Article number discontinued product	Description discontinued product	Article number substitution product	Description substitution product	Last order	Last delivery
see attached file	MICON 5 Plunger square	see attached file	MICON 5 Plunger square	Juli, 30, 2021	September 31, 2021

Change in detail

Publication date: April 23, 2021

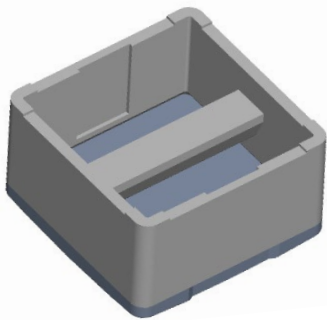
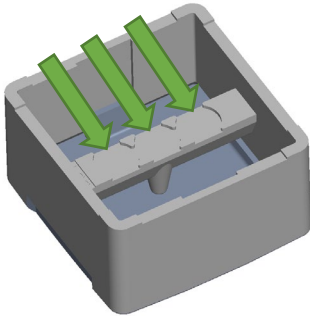
Discontinued product	Substitution product
The discontinued product does not have notches for the MICON 5 plunger. The snap disk in the short-travel keyswitch is not protected against excessive actuation. 	Notches for the MICON 5 plunger allow the actuating force to be absorbed by the MICON 5 housing in the event of excessive actuation. This protects the snap dome from high force effects and prevents possible breakage.
